SSD 7388 - MOD 6

The Ribbon - 31 Wheat Road

Submitted to The Department of Planning and
Environment

Figure 1 - Comparison of original and proposed DA design concepts.

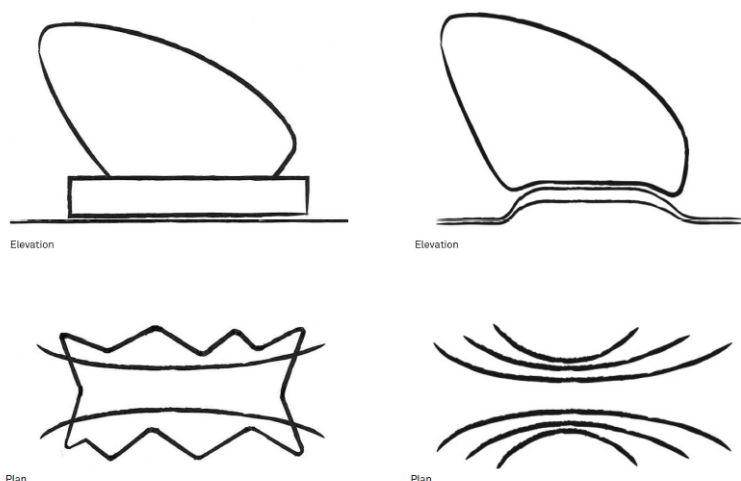
As part of the ongoing design refinement process of The Ribbon, Hassell has undertaken a holistic review of the building and its relationship to the surrounding area. The original DA concept may be interpreted as a vertically curling ribbon (tower) resting upon a horizontally undulating ribbon (podium). The proposed development concept sought strengthens and reinforces this idea further by aligning the geometry of the tower and podium. In this way, the composition may be interpreted as a series of sweeping, dynamic curves that reinterpret the lines of the Western Distributor into a shape that similarly creates a strong focus at its centre (the hotel main lobby and atrium) while reaching out towards the public domain and Darling Harbour beyond. The nested, projecting curves of the podium also cleverly negotiate the complex offsets from the RMS overpass structure, optimising the interior floor area and rationalising the shapes of the rooms and improving their visual connectivity to the harbour.

Figure 2- Comparison of the approved (purple) and proposed (red) building envelopes, as visible from the North-Eastern and North-Western building elevations.

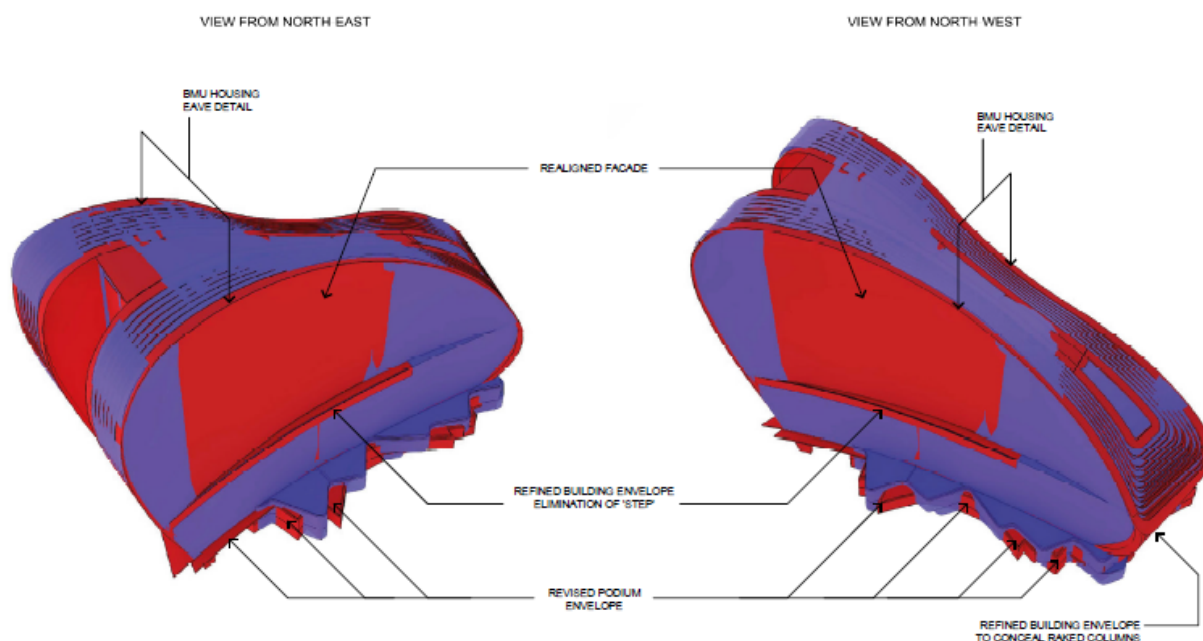
The overall shape of the development has been rationalised, with specific revisions sought across the tower element of the proposal. Overall, the proposed revised envelope generally reflects that previously approved, with the intention of ensuring that previously projecting elements of the envelope can instead be incorporated into the building form itself.

Figure 2 below provides a comparison of the development, which demonstrates this minor change.

Figure 3 – Comparison of approved (left) and proposed (right) Level 22 floor layouts.

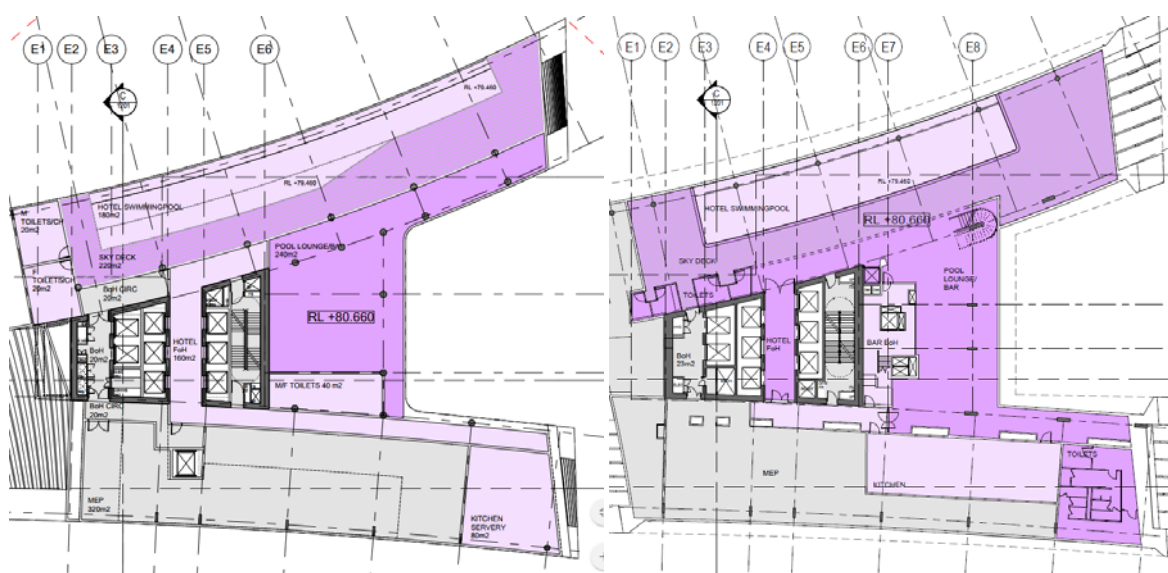
Another key change of this modification application is a reconfiguration of the hotel swimming pool facilities, in order to enable the development to be open to the sky. Previously, Levels 22 and 23 of the development proposed the provision of an indoor Pool and Lounge / Bar, with a Specialty Restaurant above. This arrangement has been redesigned under the proposed modified design, so as to facilitate provision of the following:

- the provision of a larger Hotel / Swimming Pool area, which is open to the air above;
- the provision of a pool lounge / bar area adjacent; and
- the provision of a mezzanine area above the pool.

Additionally, it is proposed that the reconfigured area be revised such that is open to the sky above. As a result of the corresponding mechanical plant area which was previously located above the pool, has been relocated elsewhere throughout the site. This includes the movement of the BMU facilities to another part of Levels 23 and 24. A comparison of the approved and proposed pool areas at level 22 has been provided at **Figure 3** below, which demonstrates the proposed amendment.

Figure 4 – Photomontage of the development, including the proposed decorative lighting

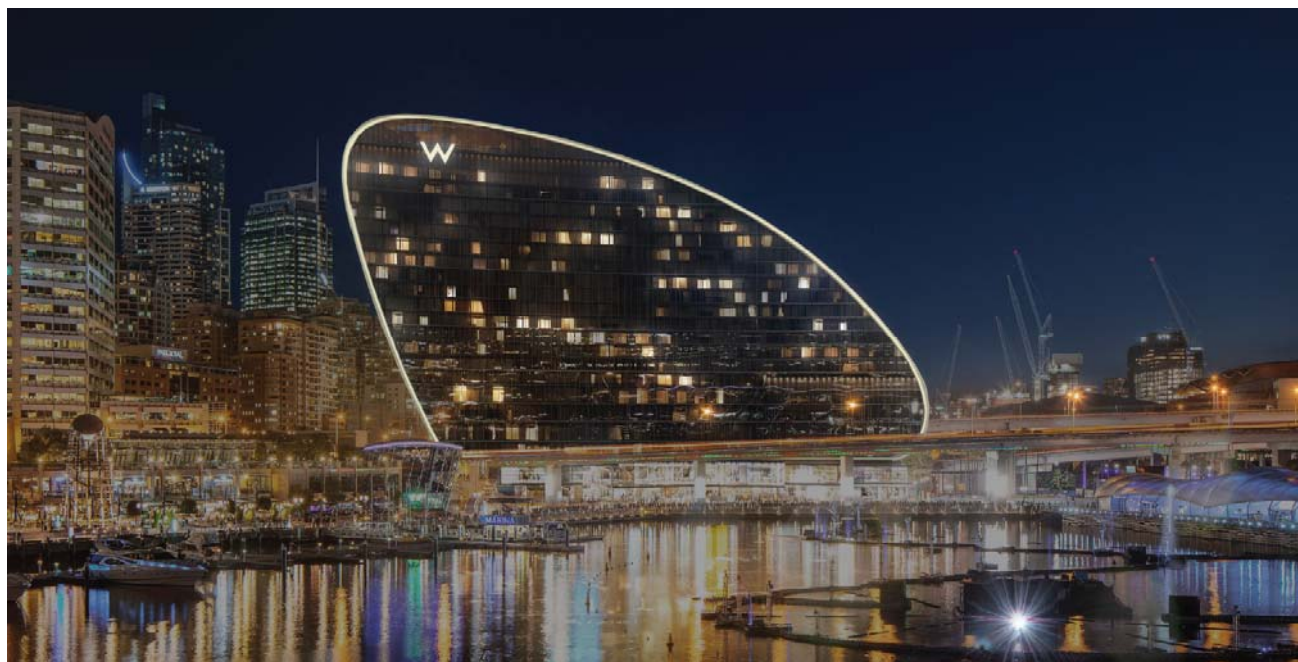
As part of the modification application, it is proposed that the modified development also includes the installation of decorative lighting around the edge of the building. This façade lighting will be at the north-western and south-eastern facades of the development, and is proposed in order to accentuate the key architectural elements of the building. The proposed lighting system comprises a series of 3000K colour temperature white light sources that vary in intensity to create a slow, subtle chase effect around the building. It is noted that all lighting will be shielded, using a perimeter 'eyebrow' façade lighting detail so that the light sources are fully concealed from view in all directions. The proposed lighting approach will result in a visual effect comparable to **Figure 4** below.

It is proposed that the development will comprise a subtle 'chase' effect around the perimeter lighting each night between dusk and 12.00am, with the lighting proposing to then remain static for the curfew period between 11.00pm and 6.00am. A full assessment of the proposed illumination has been undertaken at **Section 5.6**.

Figure 5 – Comparison of approved (green) and proposed (pink) tower envelopes at the site.

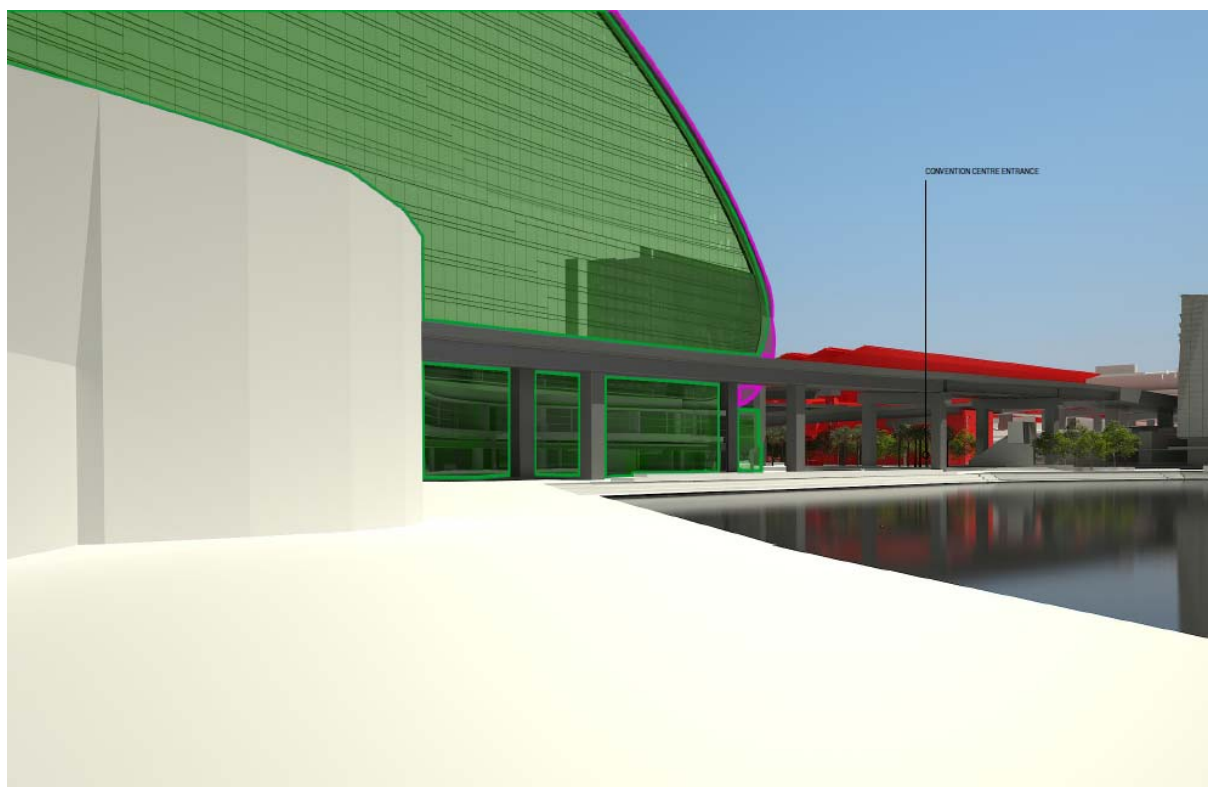
A comparison perspective, which highlights the existing envelope (green) against the proposed envelope (pink) has been provided in the Visual Impact Assessment (**Appendix C**), and a perspective which highlights additional bulk at the tower portion of the site as viewed from the public domain walkway to the north of the site has been reproduced at **Figure 5** below. Overall, the proposed revised tower envelope will continue to be of a high quality design and demonstrate design excellence.

Figure 7 – Minimum clearances maintained between the proposed development and the Western Distributor.

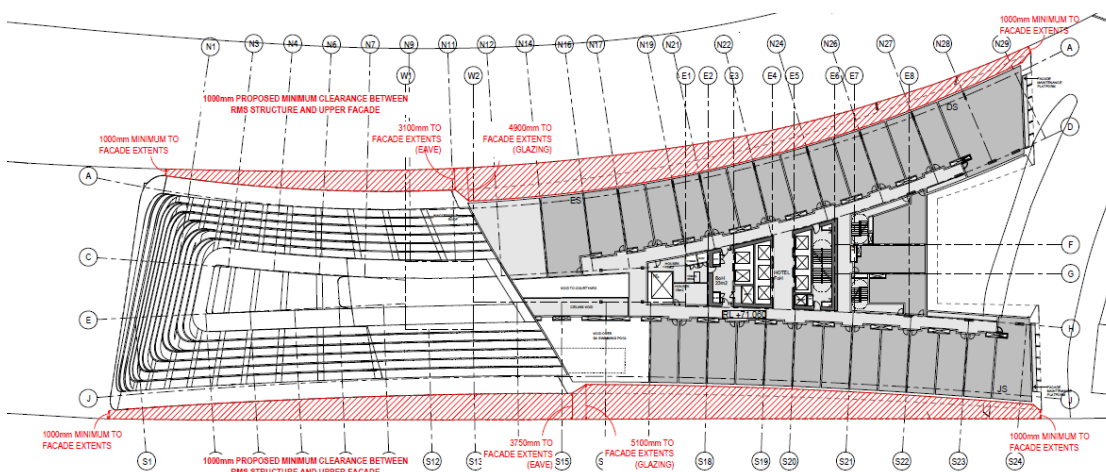
A key consideration in the revised design of the building envelope was that it would need to continue to comply with the relevant minimum clearances from the Western Distributor. This includes a minimum 2000mm horizontal clearance up to 5.5m above the roadway, and a minimum 1000mm horizontal clearance above 5.5m above the roadway. Additionally, a minimum 2000mm vertical clearance has been maintained between the development and the Western Distributor. **Figure 7** below provides a floor plan excerpt which demonstrates the maintenance of the 1000mm minimum horizontal clearance, and demonstrates that for the majority of the building envelope the envelope exceeds the minimum clearance area.

The proposed clearances under this modification application do not include any change from those previously approved under the base building DA. On this basis, the proposed revised tower envelope is considered to be acceptable in the context of the site, and will provide adequate clearance for RMS assets.

Figure 8 – Comparison of additional (green) and reduced (yellow) overshadowing to the playground at Tumbalong Park as a result of the proposed modified development.

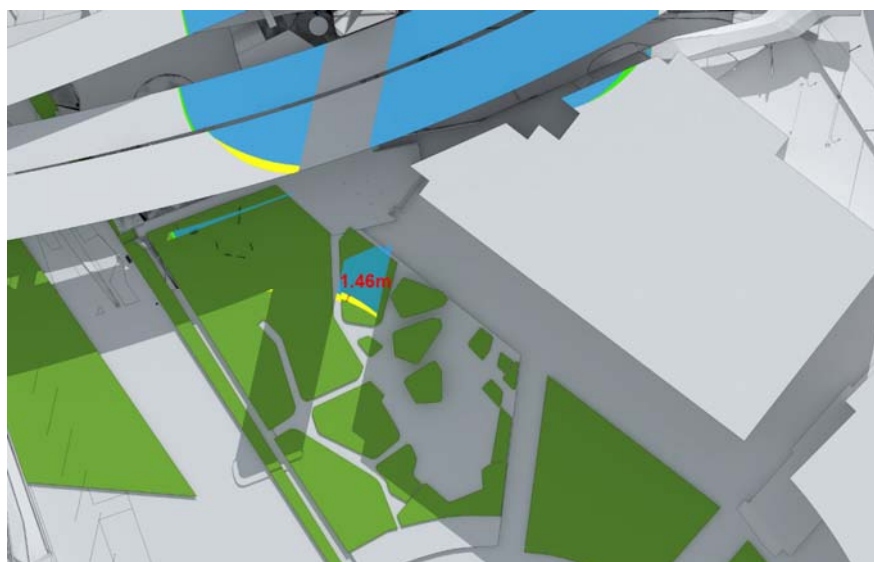
A comparison of the overshadowing impacts of the approved and proposed building forms at the site has formed part of the documentation at **Appendix A**. Specifically, it is noted that the revised tower form will work to reduce overshadowing impacts to the playground at certain times of year. **Figure 8** below provides an excerpt to this respect, demonstrating the additional solar access that the revised design will provide to the playground at 11.00am on 21 June.

Although it is noted that some spaces will result in negligible additional shadowing as part of the revised building envelope, the vast majority of the additional overshadowing will be onto the roof of the Commonwealth bank building, or on to the Western Distributor. Overall, it is considered that the revised building envelope will result in a minor positive net impact on the surrounding area, by comparison to that currently approved.
